21 March 2012

ZGA Architects and Planners, Chartered  
408 E. Parkcenter Blvd, Suite 205  
Boise, Idaho 83706

Re: **ADDENDUM NO. ONE**  
**VAMC Building 85 Replace and Modernize Surgery / I.C.U.**  
**VA Project # 531-371**  
500 West Fort Street Boise, ID 83702  
ZGA Project No. 1018.00

# BUILDING 85 – THIRD FLOOR DEMOLITION PLAN

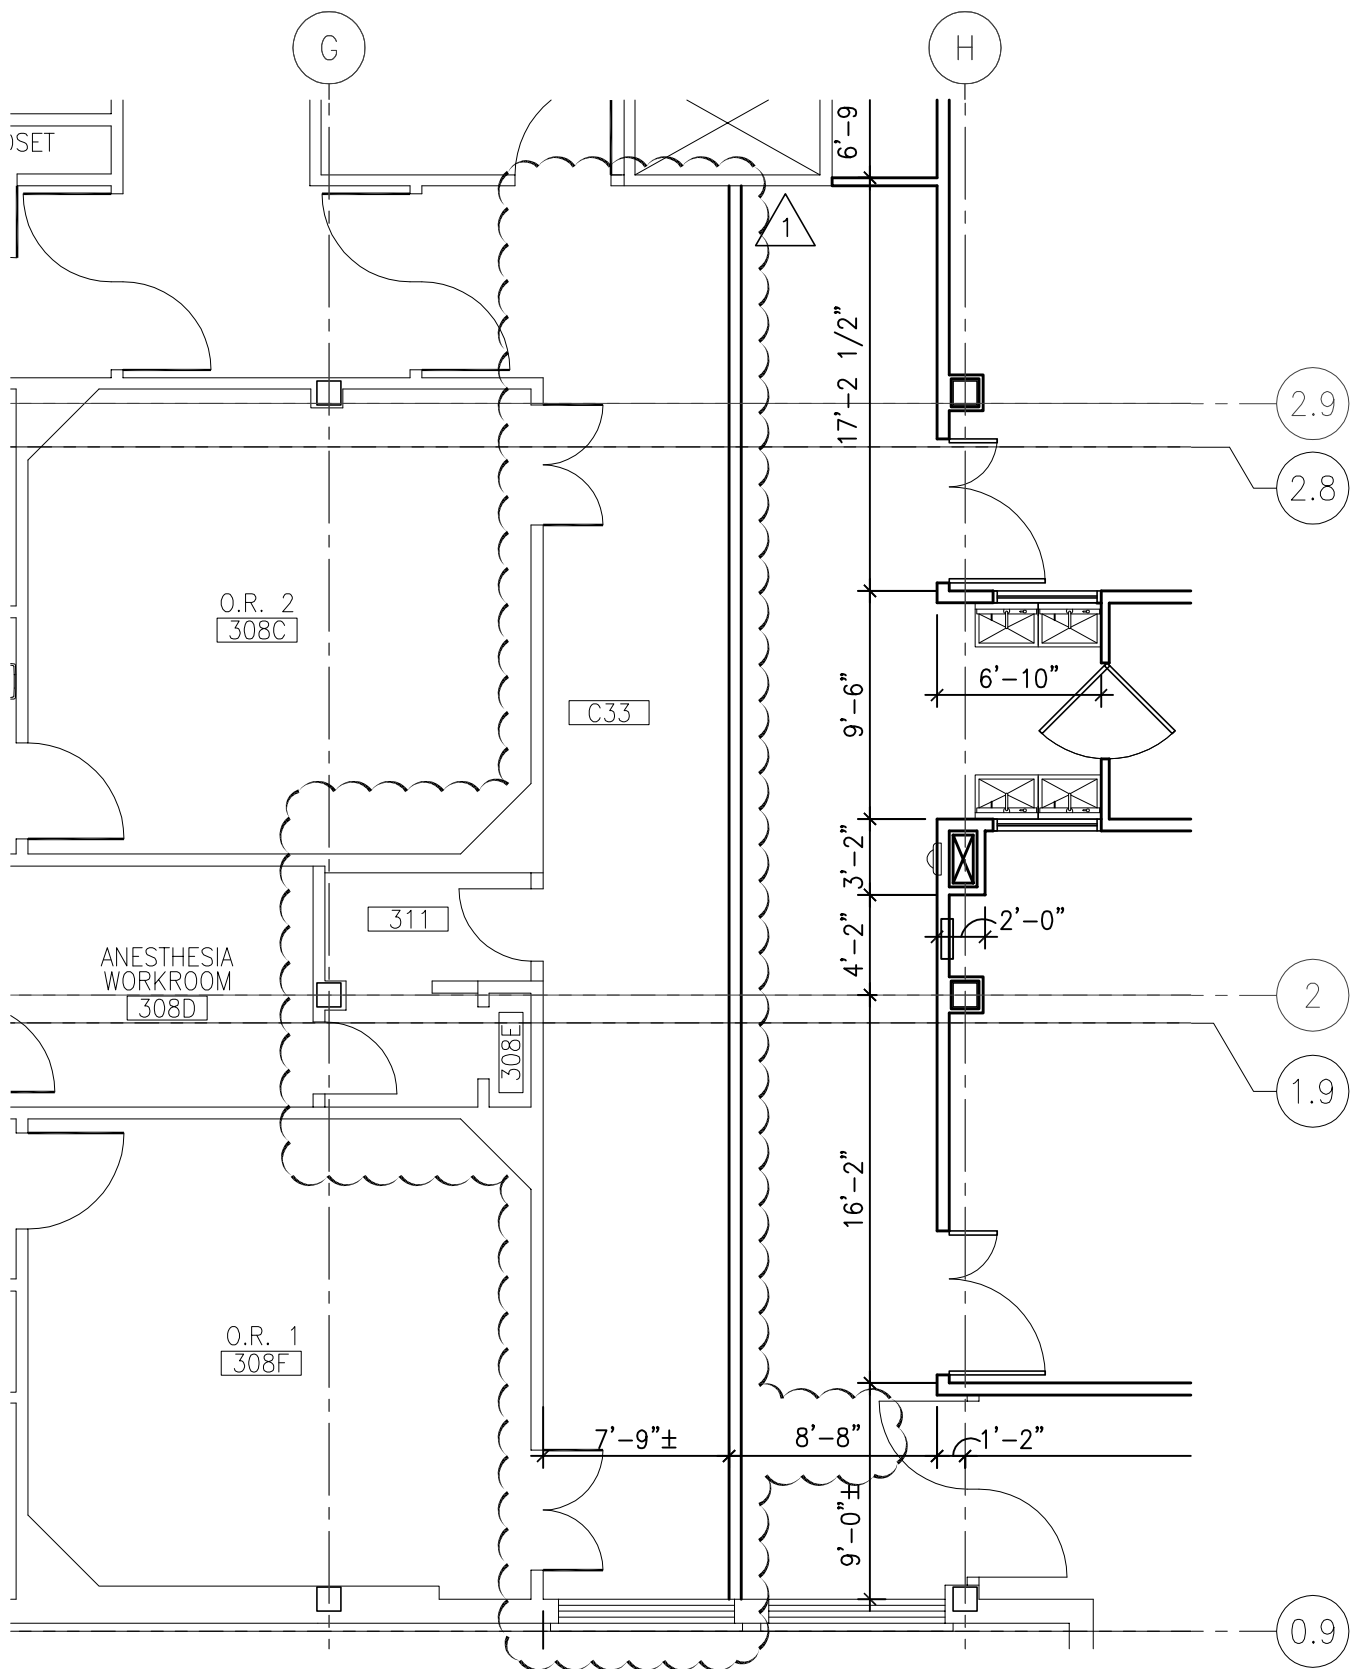
- b. Modify Sheet A1.3, Building 85 – Third Floor Demolition Plan per sketch AA-01.
- c. Modify Sheet A2.3A, Building 85 – Third Floor Dimension Plan per sketch AA-02.

# BUILDING 85 – THIRD FLOOR NOTATED PLAN

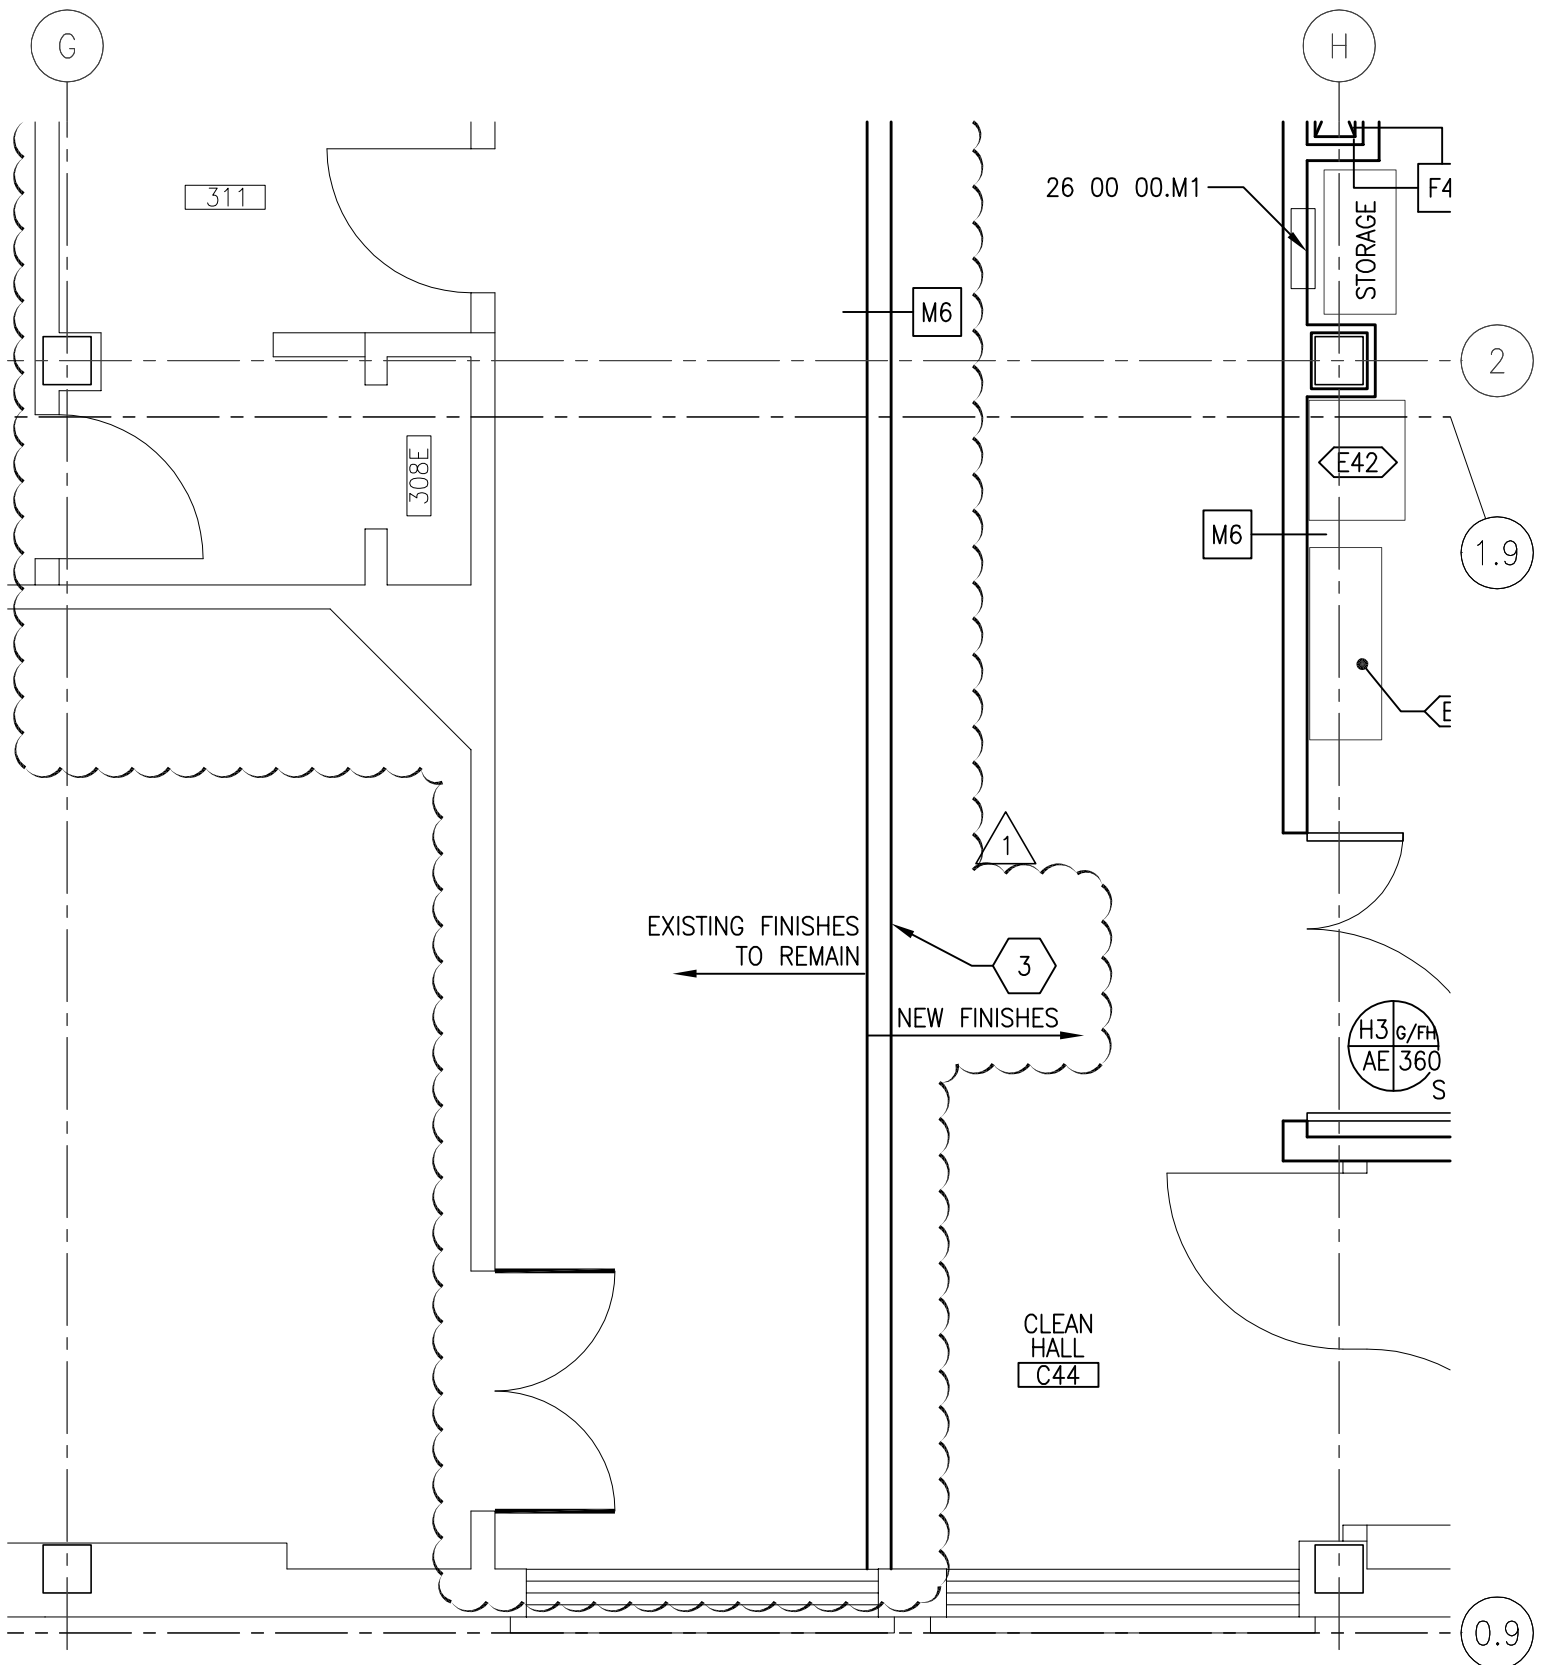
- d. Modify Sheet A2.3C, Building 85 – Third Floor Notated Plan per sketch AA-03 and AA-04.
- e. Modify Sheet A2.9, Building 85 – Third Floor Finish Plan per sketch AA-05. Rooms 309A (ICU/Surgery Storage) and 363 (Clean Supply) shall no longer require FRP wainscot. Walls shall receive paint full-height. Both sides of dividing wall between Corridor 33 and Corridor 44 shall receive paint per Specifications. Changes made within these sketches and addendum shall take precedence over finishes listed in the Finish Schedule.

REF. SHEET: A9.3 ISSUED WITH: AD-01

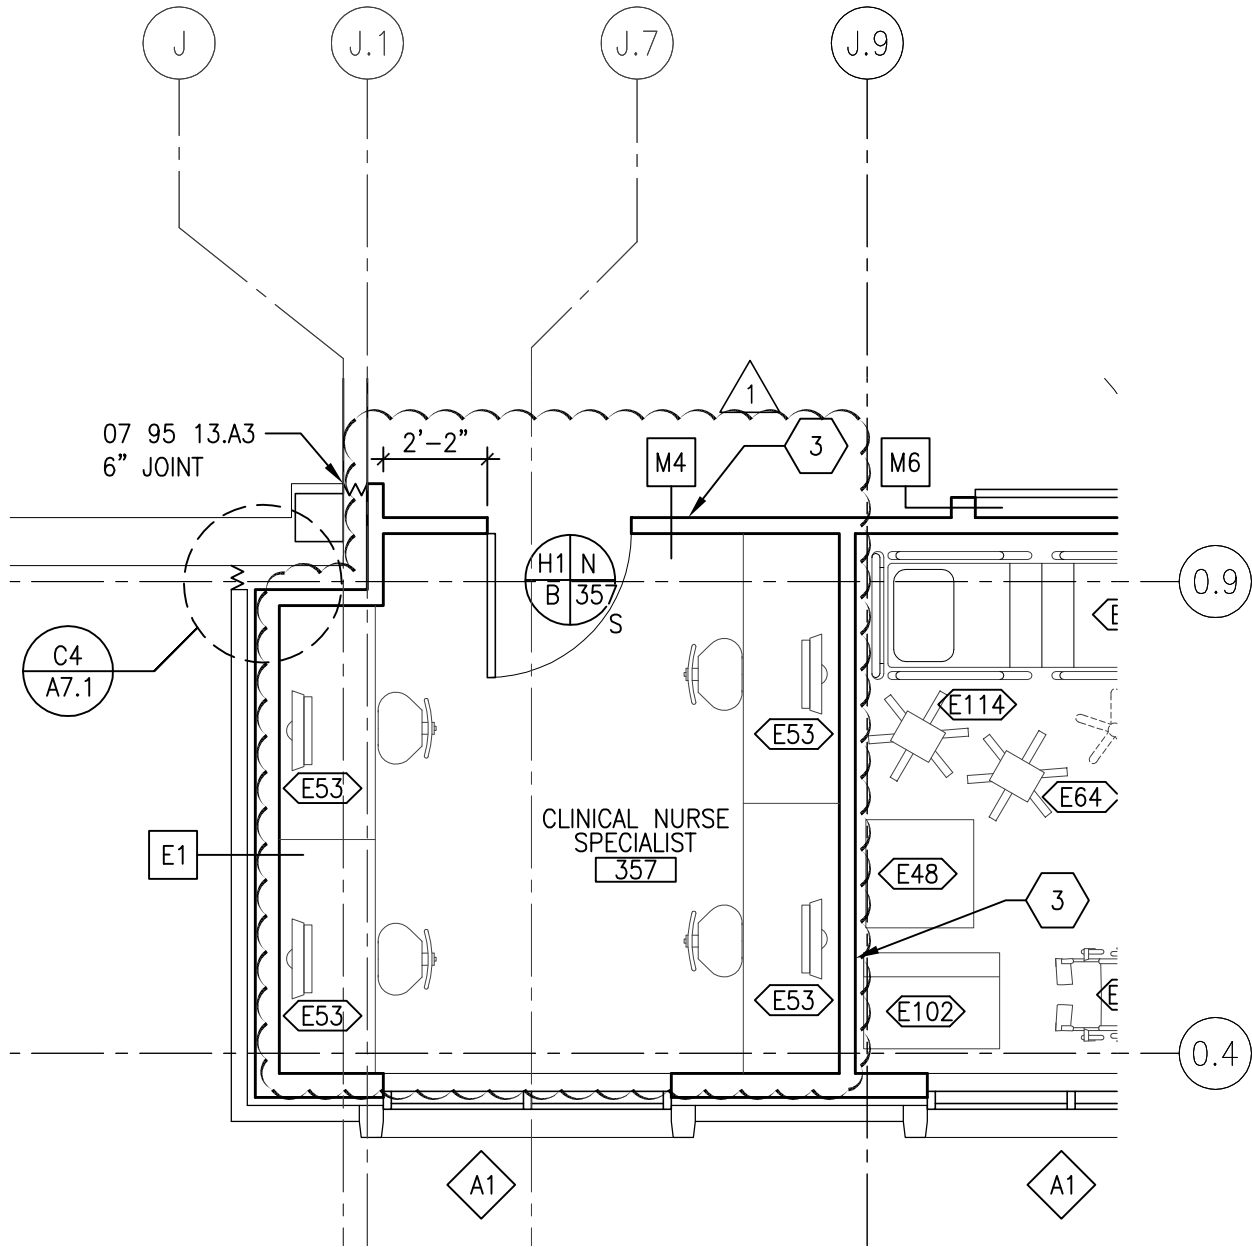
- f. Modify Sheet A9.3, Building 85 – Third Floor Reflected Ceiling Plan per sketch AA-06.
- g. Retain and protect existing electrical in Anesthesia Workroom 308D, Room 311, Room 308E, and Corridor C33. No new electrical outfitting shall be done in corresponding rooms Anesthesia Workroom 308D, Suture Storage 310, or Orthopedic Storage 311. Coordinate extents of existing area to remain with architectural sketches.

# BUILDING 85 – THIRD FLOOR NOTATED PLAN

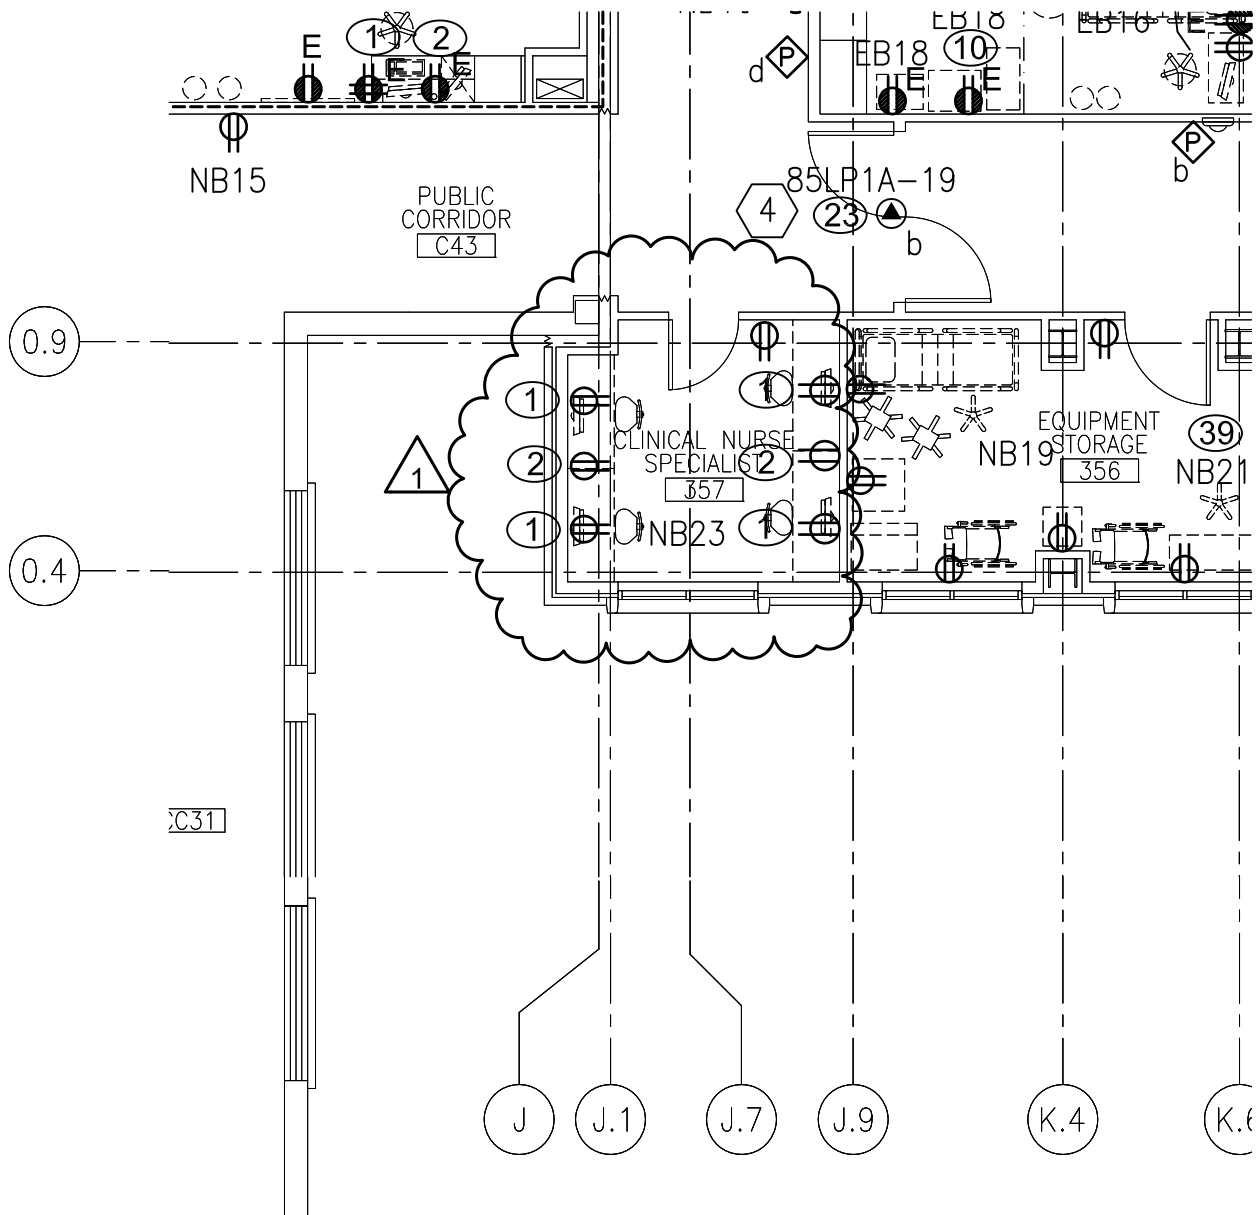
- b. Modify Sheet A2.3C , Building 85 – Third Floor Notated Plan – Area B, Room 357 (Clinical Nurse Specialist). Relocate Door 357 to center of room as shown in sketch AA-07 and modify hardware set as indicated above. Delete all built-in casework from room.

- c. Delete Sheet A8.1, ICU Interior Elevations 4, 5 & 6 in their entirety. Workstations shown in sketch AA-07 will be provided as furniture by the Owner.

# THIRD FLOOR POWER PLAN 1/8"=1'-0"

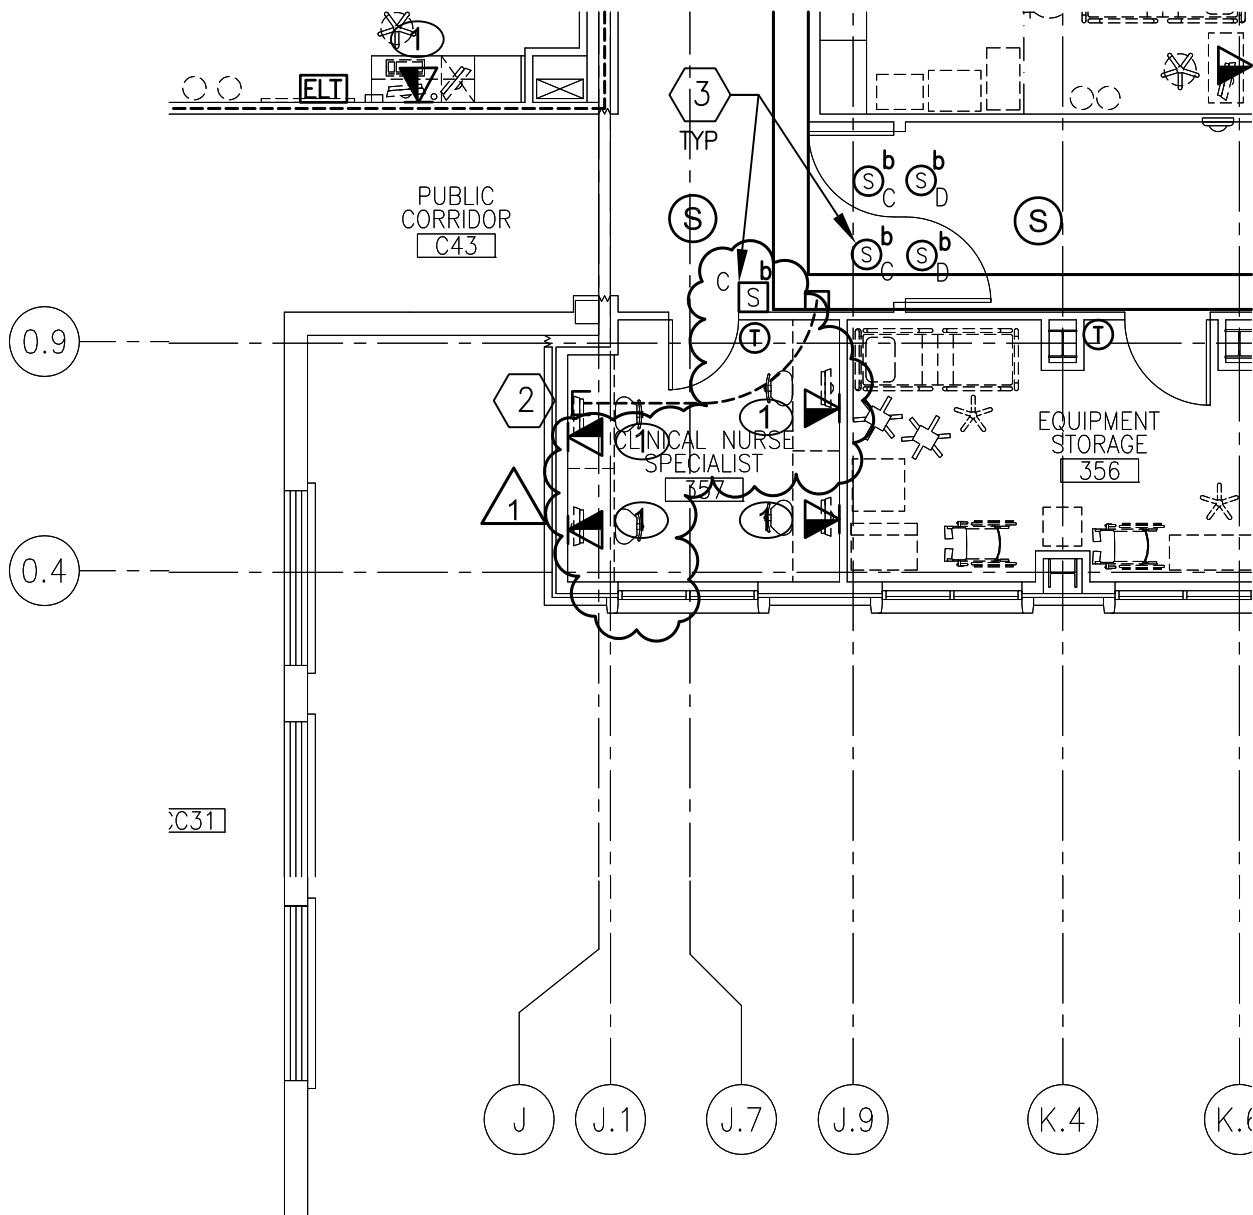
- d. Modify Sheet EL2.3, Third Floor Lighting Plan. Relocate light switches in Clinical Nurse Specialist 357 next to new door location. No sketch.
- e. Modify Sheet EP2.3, Third Floor Power Plan in Clinical Nurse Specialist 357 per sketch EA-01.
